IN THE UNITED STATES PATENT AND TRADEMARK OFFICE

D. Amendments to the Drawings.

E. Remarks

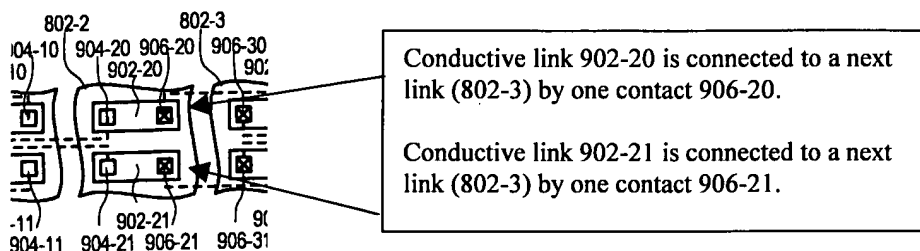
Applicants understand that any n -bit binary value can provide 2^n different binary numbers. However, this is not the case for conventional mask revision codes as described in Applicants' BACKGROUND ART. This is explained in the BACKGROUND ART of Applicants' Specification:

A drawback to conventional approaches, such as that described above, can be the limited number of mask revisions that may be expressed for a given set of mask bit ID circuits. *In particular, for n mask ID bits, only n mask revisions may be expressed.* Such a limitation can exist because once a change is made to a mask ID bit, the bit value may not be changed back unless the same mask layer is changed. (Applicants' Specification, Page 4, Lines 19-24).

Accordingly, because the described conventional approach shows the ability to express only n mask revisions from n mask ID bits, such teachings do not show, and are not believed to suggest Applicants' claim 8 limitations.

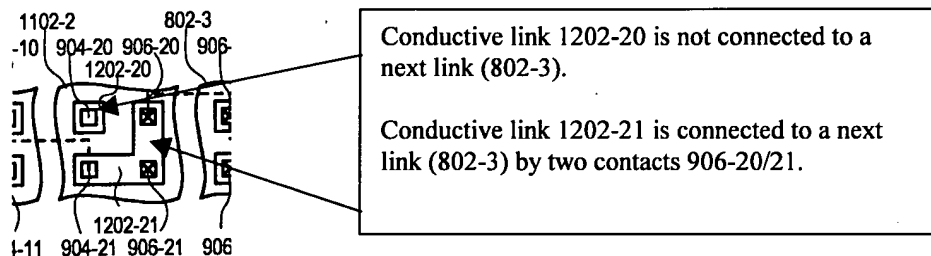
5 In the arrangement of the BACKGROUND ART, in one configuration, the conductive lines of a link are coupled to a next link by one contact:

However, in a second configuration, one conductive line is connected to the next link by two contacts, while the other conductive line is not connected to the next link at all.

Accordingly, Applicants believe that amended claim 13 recites limitations not shown in the BACKGROUND ART.
